Access Compliance Report

Public Rights-of-Way

(Curb Ramps)

Intersection ID: 21952	Main Street: AUTUMN_BLAZE_DR	Cross Street: SHADEMASTER_PL	Location: W
ADA ID: C39BB458E58D	Ramp Type: Directional1	Initial Pass/Fail: Fail	Overall Compliance: No
Severity Score: 12.5			
Codes/Mitigation Info/Possible Solution		Field Measurements/Component Compliance

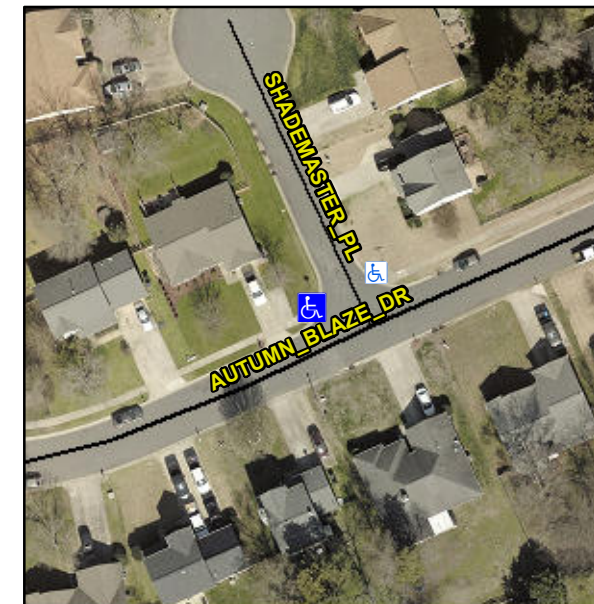
R304.2.2

Compliance	Description	Data	Compliance	Description	Data
N/A	Ramp Length (in)	48.0	N/A	Grade Break?	N/A
Yes	Ramp Width (in)	48.0	N/A	Grade Break Slope (%)	0.0
No	Ramp Slope (%)	8.8	N/A	Grade Break XSlope (%)	0.0
Yes	Ramp XSlope (%)	0.2			
N/A	Flare Type LT	N/A	N/A	Flare Type RT	N/A
N/A	Flare Slope LT (%)	N/A	N/A	Flare Slope RT (%)	0.0
N/A	Flare Traversable LT?	N/A	N/A	Flare Traversable RT?	N/A
N/A	Landing Length (in)	0.0	N/A	DWS Provided?	N/A
N/A	Landing Width (in)	0.0	N/A	DWS Contrast?	N/A
N/A	Landing Slope (%)	0.0	N/A	DWS Length (in)	N/A
N/A	Landing X Slope (%)	0.0	N/A	DWS Full Width?	N/A
N/A	Landing Curb? (Y/N)	N/A	N/A	DWS Offset LT (in)	N/A
N/A	Shared Landing?	N/A	N/A	DWS Offset RT (in)	N/A
N/A	Gutter Ponding?	0.0	N/A	Gutter Slope (%)	N/A
N/A	Gutter Lip Ht (in)	0.0	N/A	Gutter X Slope (%)	N/A
N/A	Painted X Walk1?	No		Road Slope (%)	2.0
	X Walk 1 Direction	To NE		Road X Slope (%)	5.5
	X Walk 1 Width (in)	N/A		Clear Space?	N/A

X Walk 1 Slope (%)	2.0	N/A	Clear Space to XWalk (in)	N/A
	X Walk 1 X Slope (%)	5.5	N/A	Storm Grate/Utility Hazard?	N/A
N/A	Ramp inside XWalk1?	N/A		Storm Grate/Utility Type	
N/A	Any Obstructions?	N/A			N/A
	Obstruction Type		Yes	Surface Condition? (G/P)	Good
			N/A	Curb Slope (%)	6.8

Remove & Replace Entire Ramp.
